**Town of Kittery
Planning Board Meeting
January 11, 2024**

ITEM 1—181 State Road—Marijuana Business Plan — Preliminary Review

**RE: Preliminary Site Plan Review – Review Revisions
Indico Adult-Use Marijuana Retail
181 & 185 State Road, Kittery, Maine (Tax Map 28, Lot 14-2)**

**RE: Town of Kittery, Planning Board Services
Indico Adult-Use Marijuana Retail Review
181 & 185 State Road (Tax Map 28, Lot 14-2)
CMA #591.170**

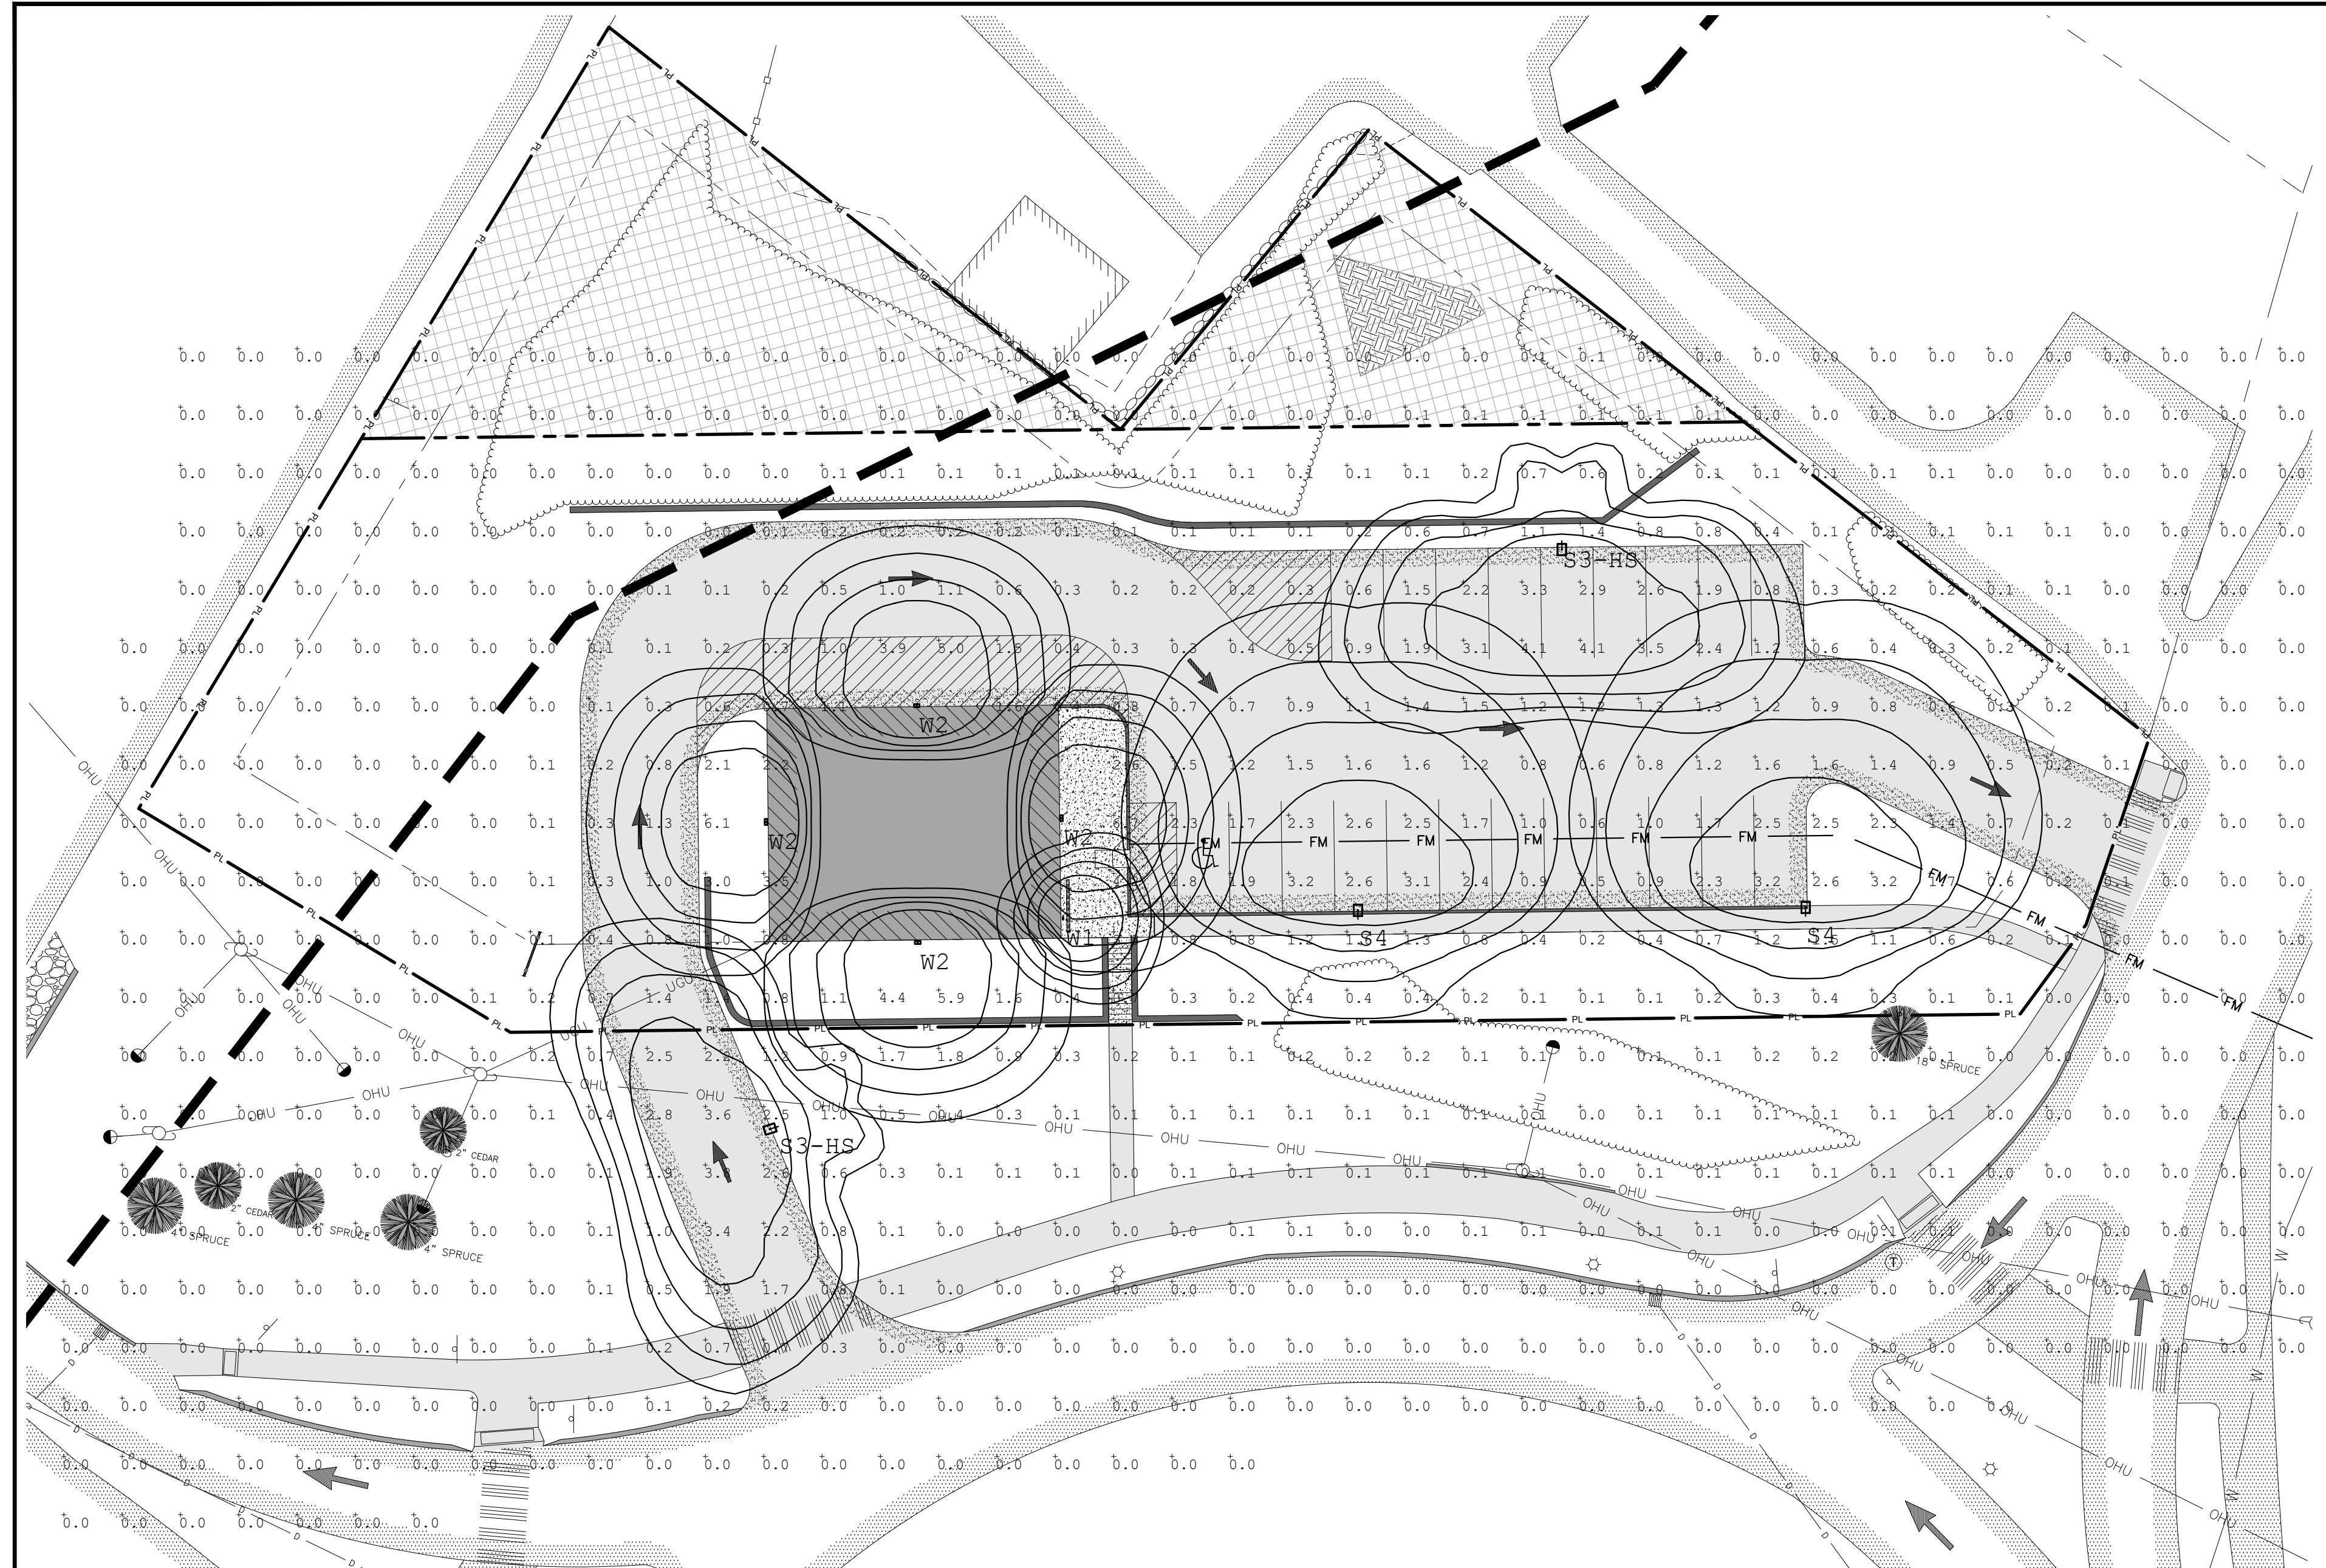
Sheet 4 – Photometric Plan

1. The plan should show uniformity ratios in accordance with the Ordinances.

- Sheet 4 (Photometric Plan) has been updated to include uniformity ratios for the proposed parking lot in compliance with §16.7.11.H.
- All relevant Plan Set sheets have been updated to include traffic flow arrows in their respective legends.

LANDSCAPING PLAN
INDICO CANNABIS RETAIL
181 & 185 STATE ROAD, KITTERY MAINE
TAX MAP 22, LOT 4

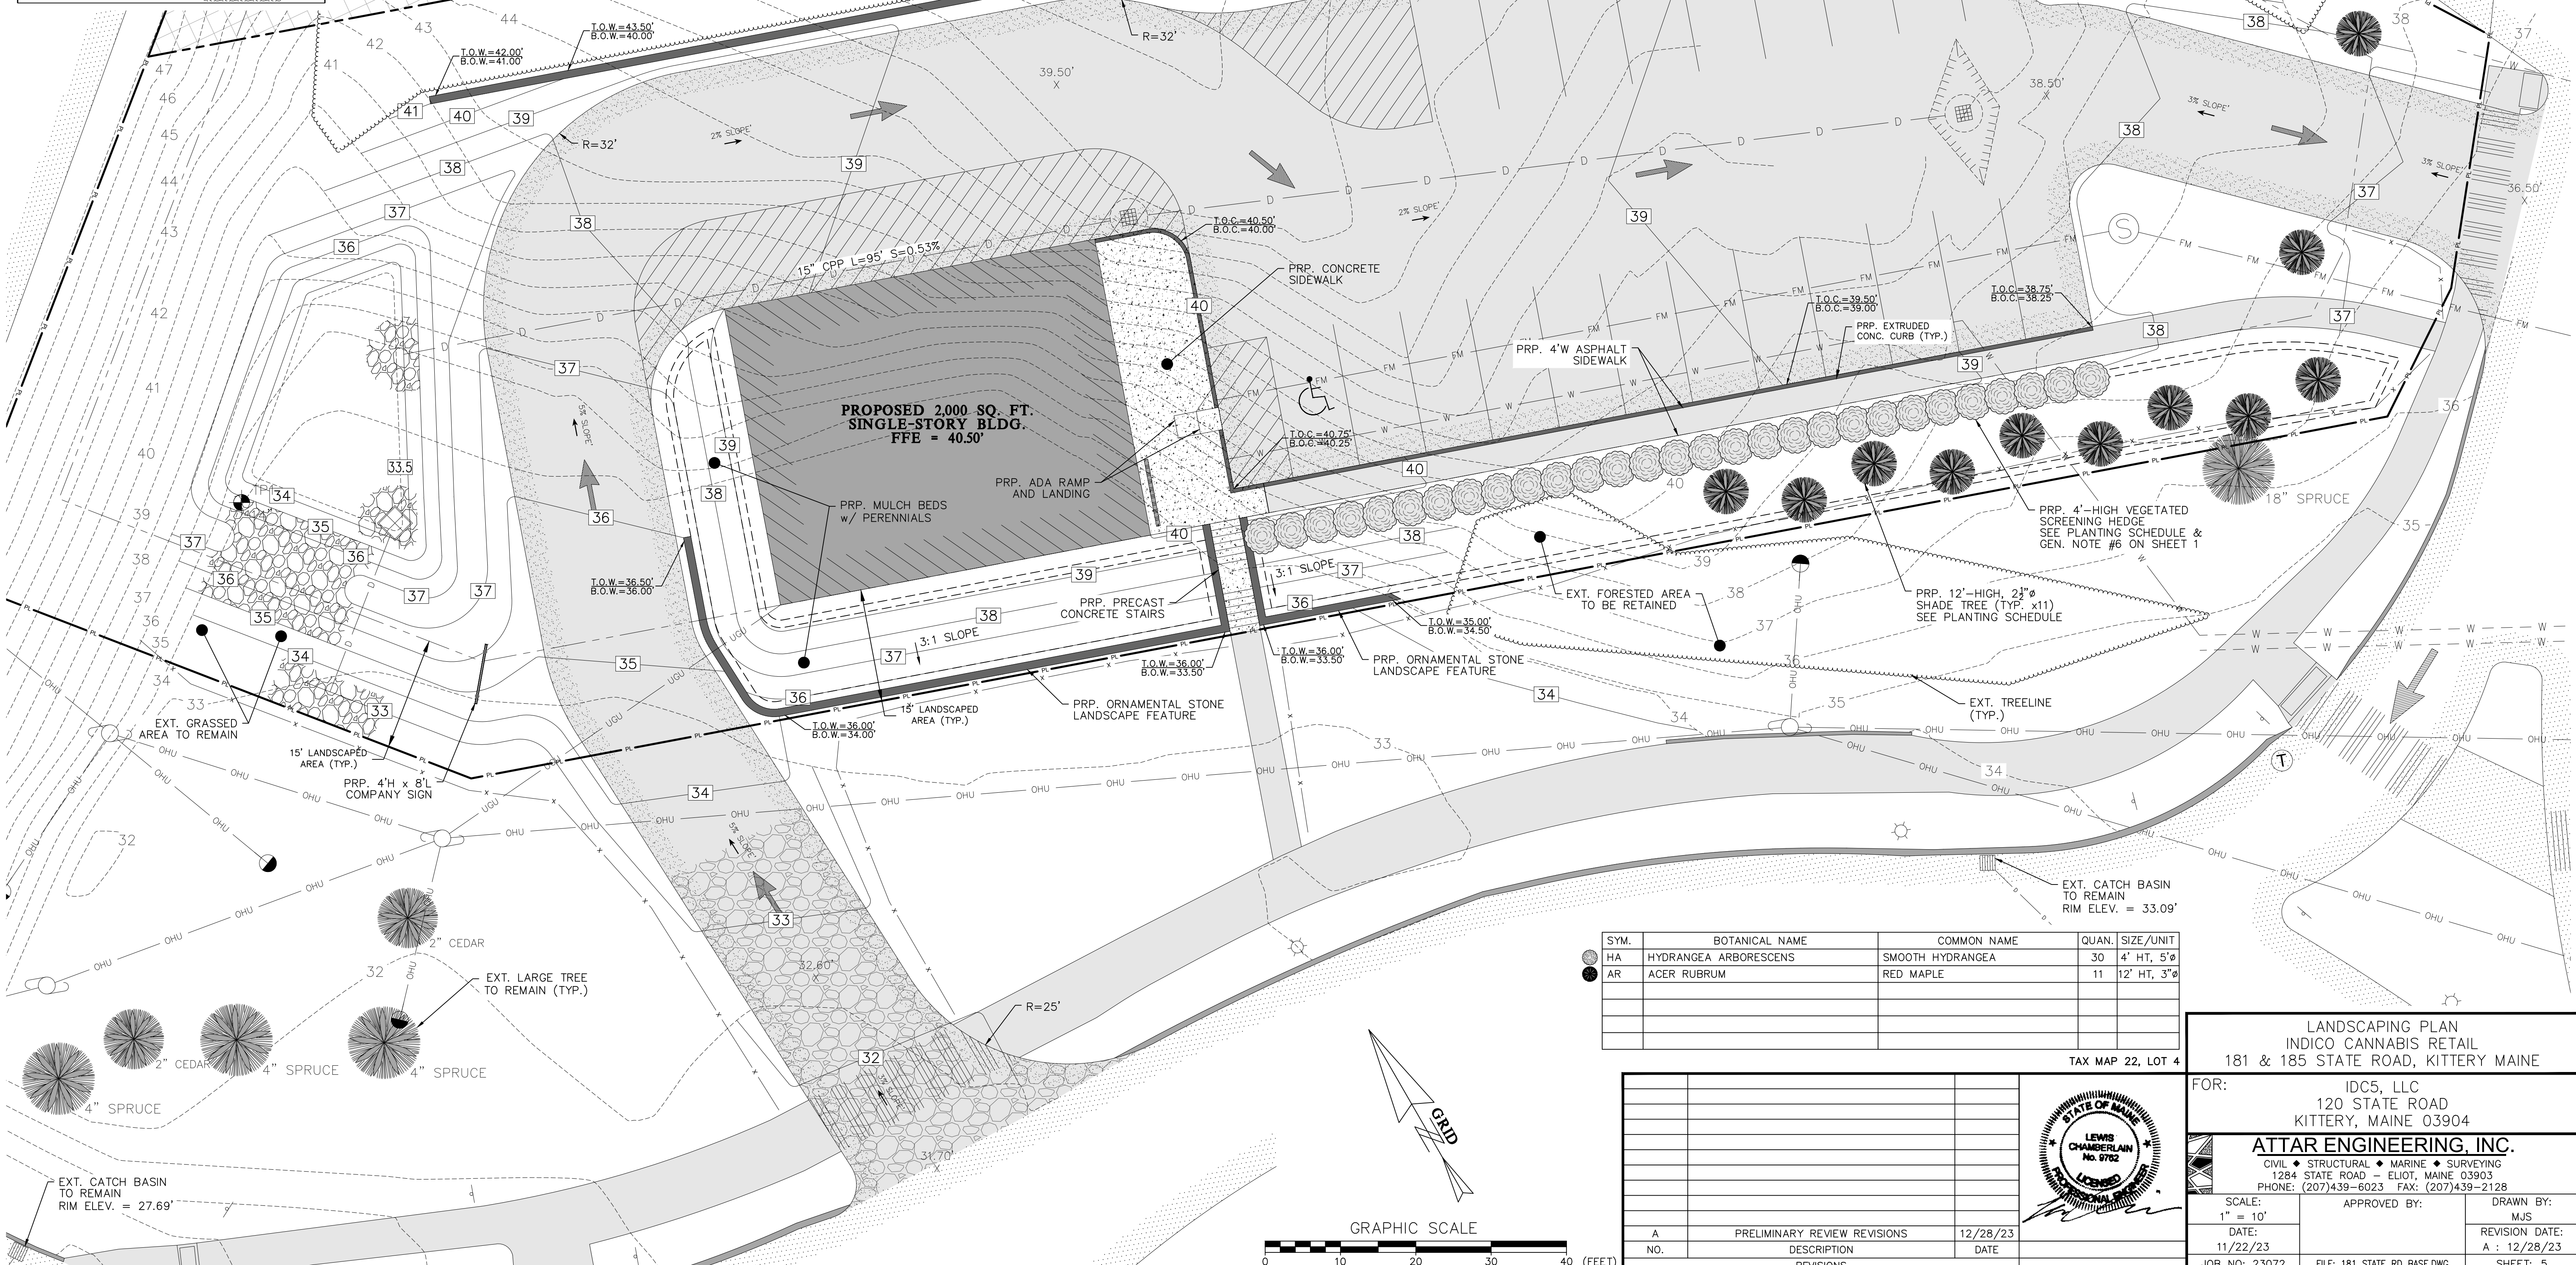
Sheet 5 – Landscape Plan

1. What is the significance of the red text and linetype?
2. What plantings are proposed within the 15’ landscaped areas?
3. There is no proposed landscaping within the parking lot as required.

- Sheet 5 (Landscaping Plan) has been updated to reflect the visual screening discussion which took place at the Planning Board meeting. A maintained 4'-high hedge line is proposed abutting the new parking lot and sidewalk to shield the traffic circle from headlight glare. Proposed tree plantings have been depicted in clustered locations along the eastern portion of the parcel's frontage, and a planting schedule has been added to display the proposed species information. Additional callouts have been provided to declare that the remainder of the 15' frontyard setback shall be vegetated with a combination of lawn, ornamental stone landscape features, and mulch beds with perennials. As discussed at the Planning Board meeting, the intent of the remainder of the frontyard setback is to have limited-height plantings which do not impede the sight lines to the building from vehicles maneuvering through the Traffic Circle.

EMERGENCY SPILLWAY DETAIL
(NTS)

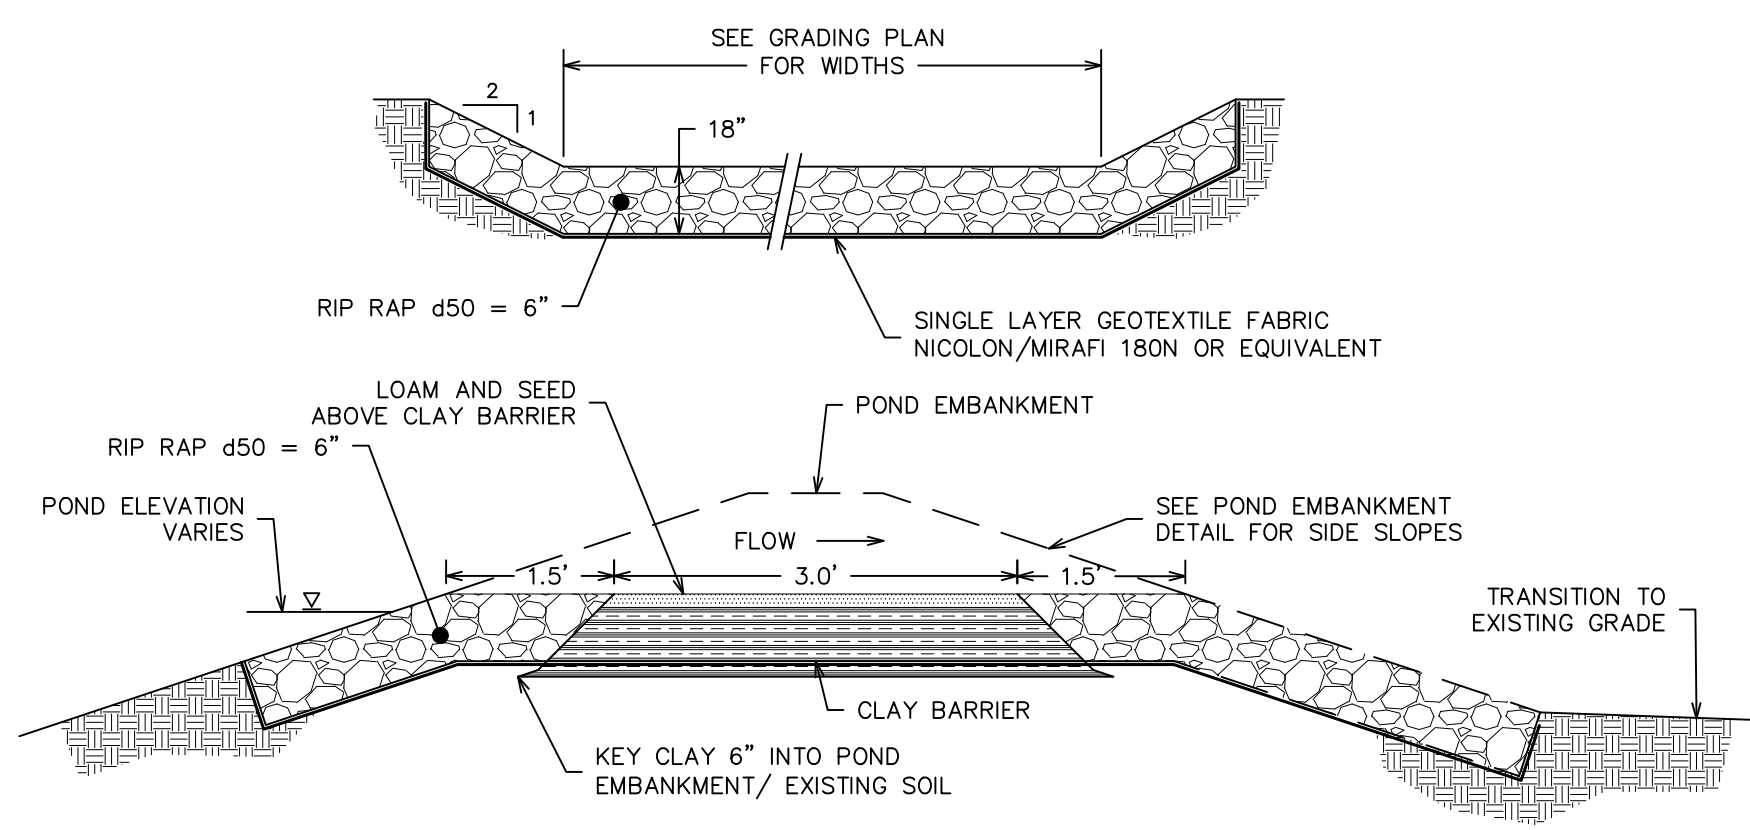
10. Include an emergency spillway detail.
11. Include a walkway detail.
12. Include details for the ADA ramps and landings.

- Sheet 7 (Site Details) has been revised to include the Emergency Spillway detail referenced by callouts elsewhere within the Plan Set.

UTILITY TRENCH PATCH DETAIL
(NTS)

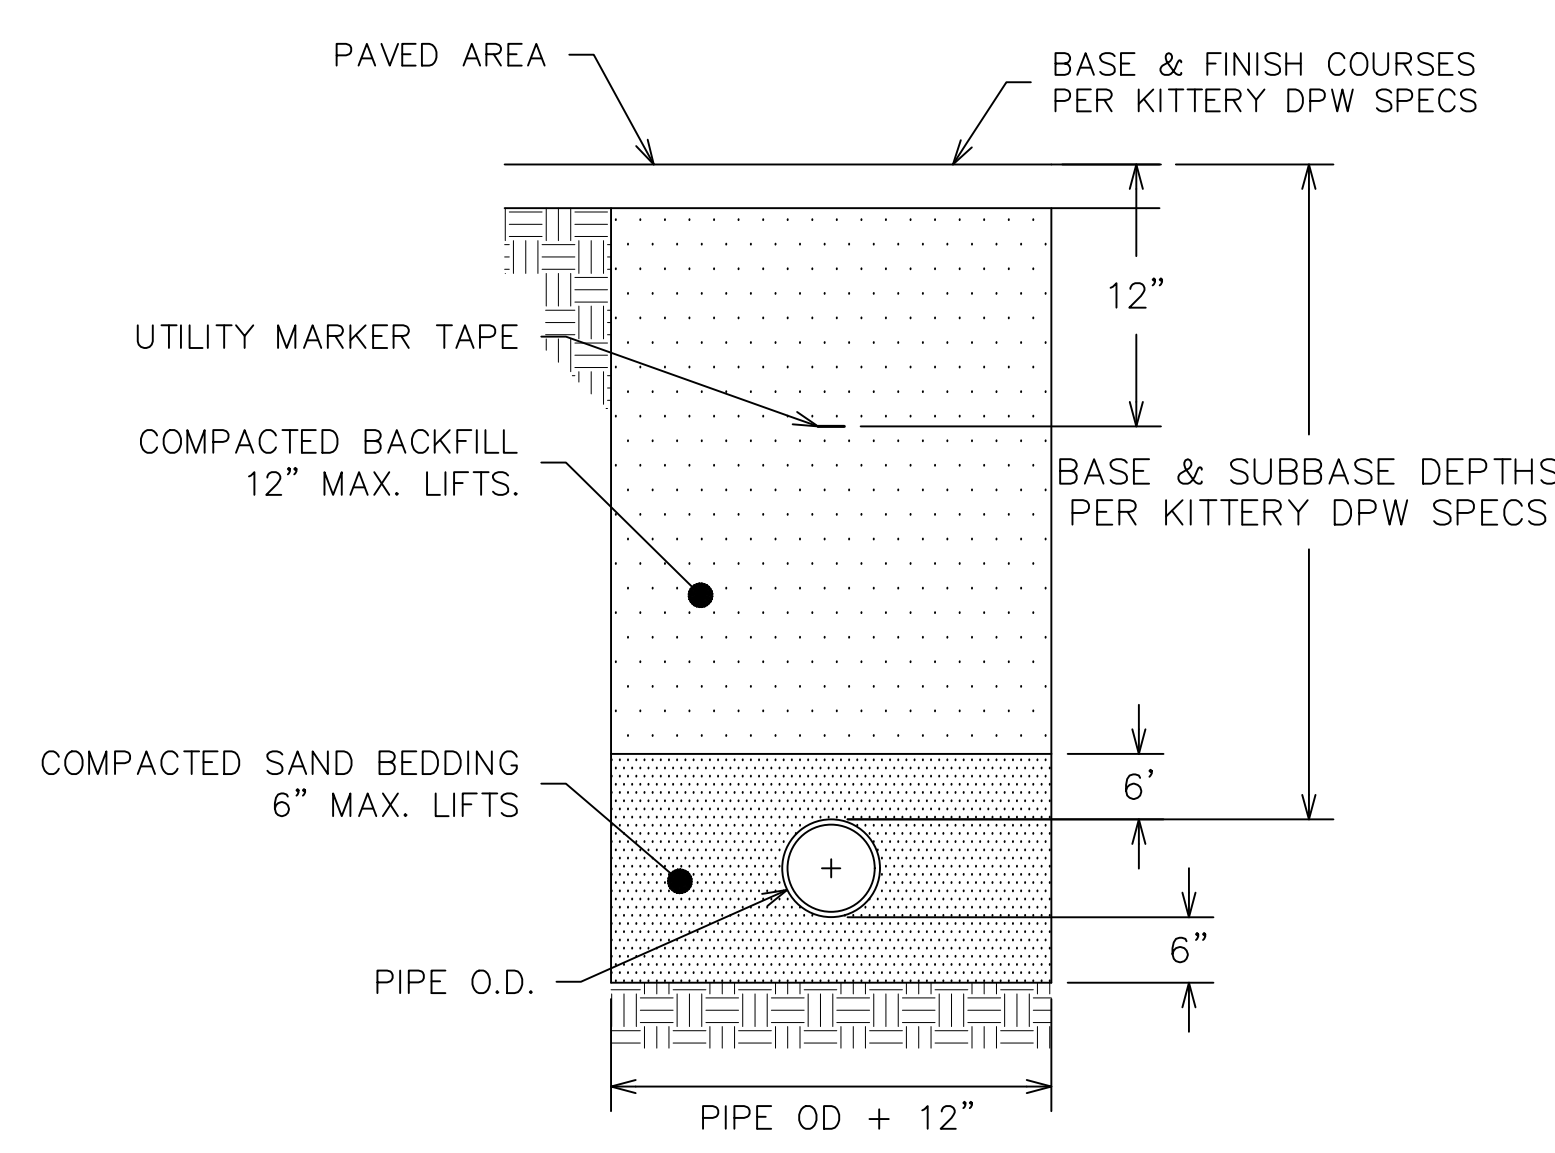
1. Update the Utility Trench Patch Detail to reflect Kittery DPW specifications. Add sawcut and tackifier.
2. The Retaining Wall Detail name should match that used on the plans (Segmental Block Retaining Wall and/or Segmental Block Landscape Feature).
